## ADDENDUM No. 1

### ITB No. 4669 - 2021 MISCELLANEOUS UTILITIES PROJECT

**BIRD ROAD  
PROPOSED TYPICAL SECTION**  
LOOKING EAST  
N.T.S.

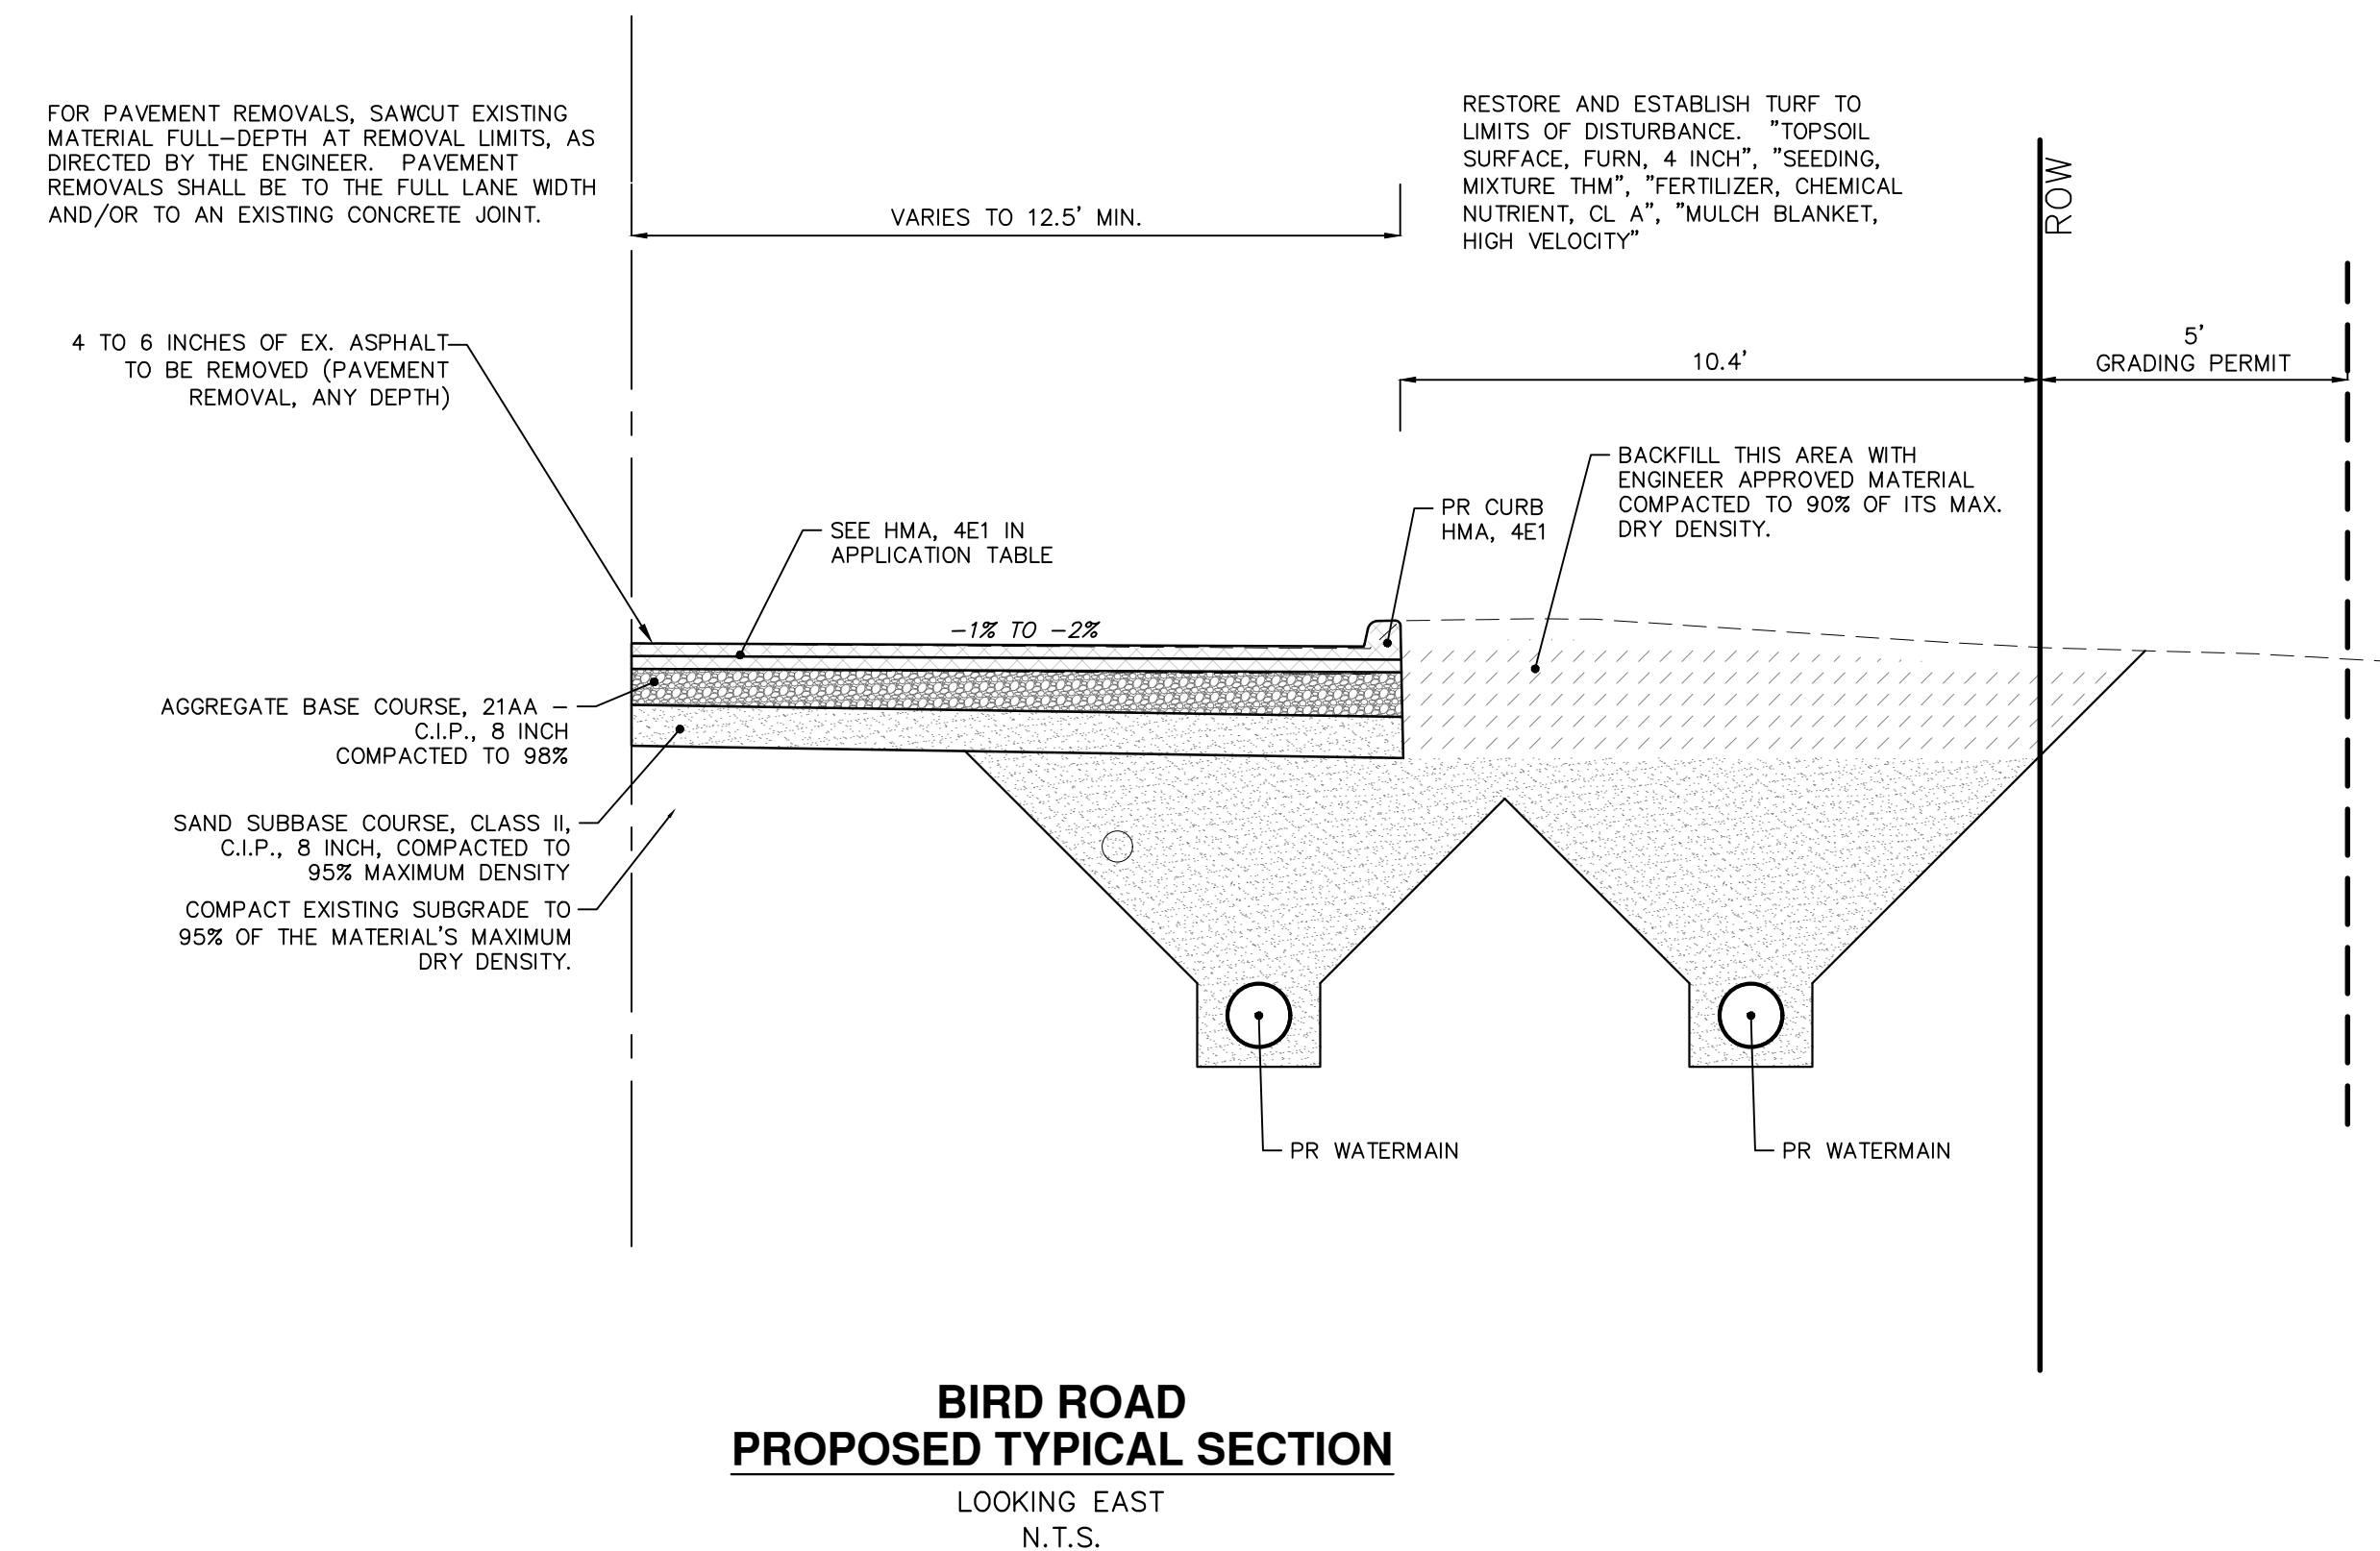
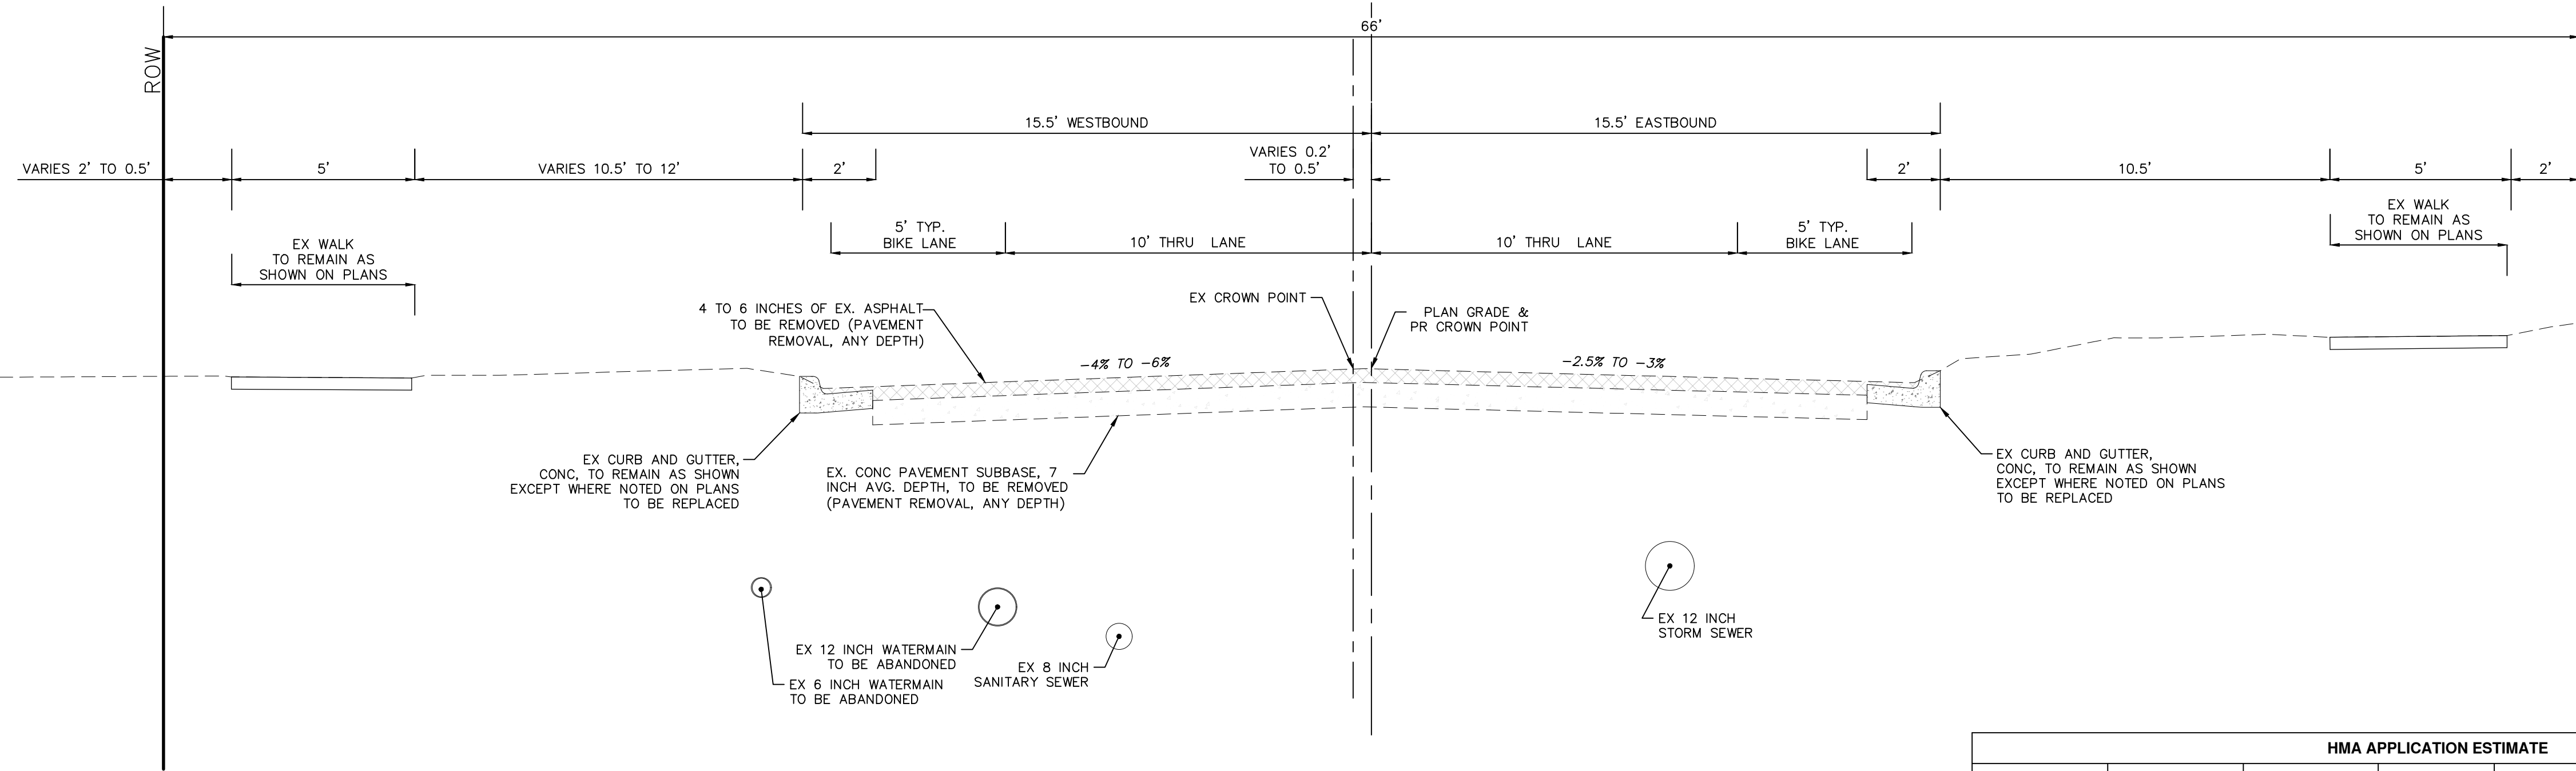
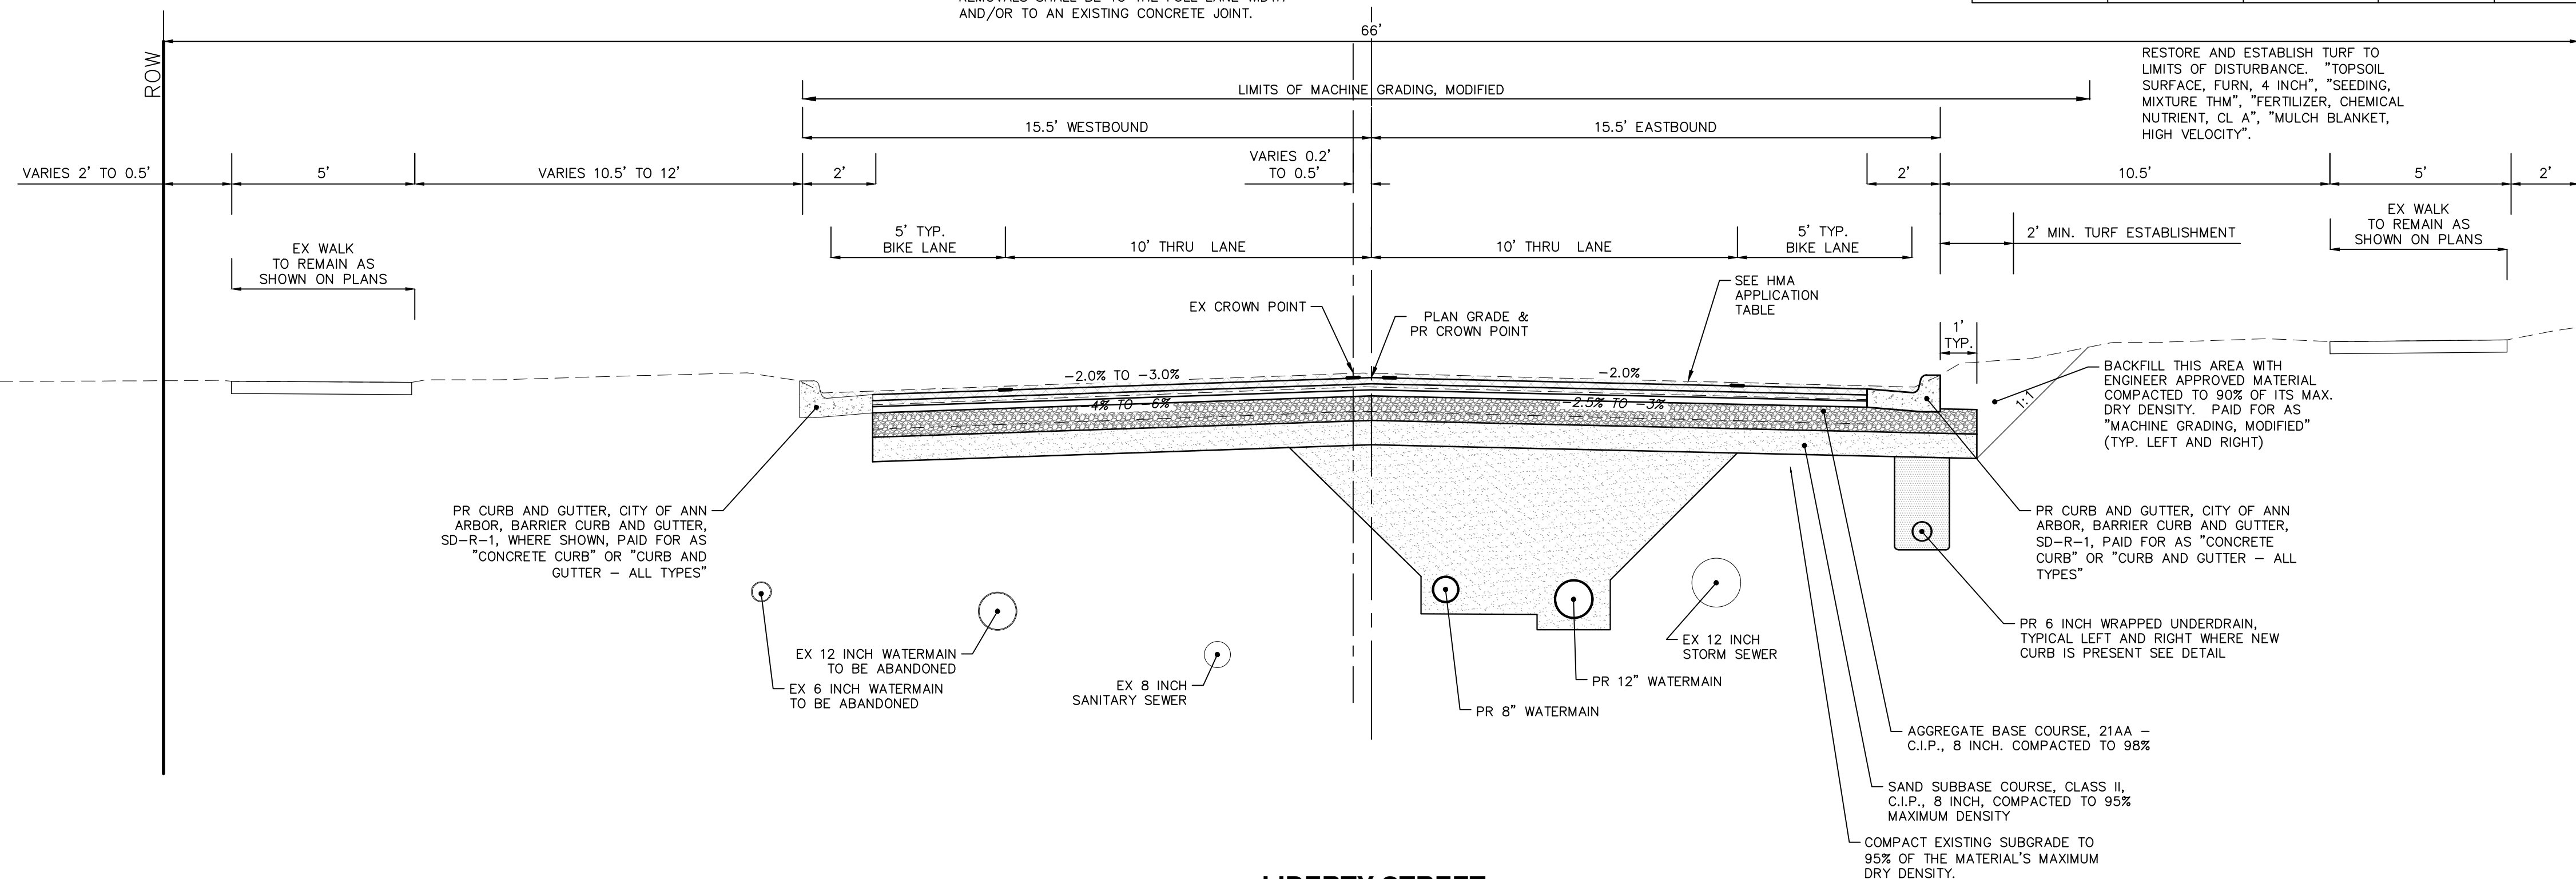
Answer 8: Pay Items 701 thru 703 have been added for soil erosion control pay items.
- Question 9: Please detail how the AREA for "Machine Grading" will be calculated. The specifications are silent as to how the transverse / longitudinal limits are to be determined.

Answer 9: Machine grading limits are calculated to the edge of the 1:1 slope outside of road grading as indicated in the street proposed typical sections on Sheets 4 thru 7. Additional clarification has been added to the Machine Grading specification section.
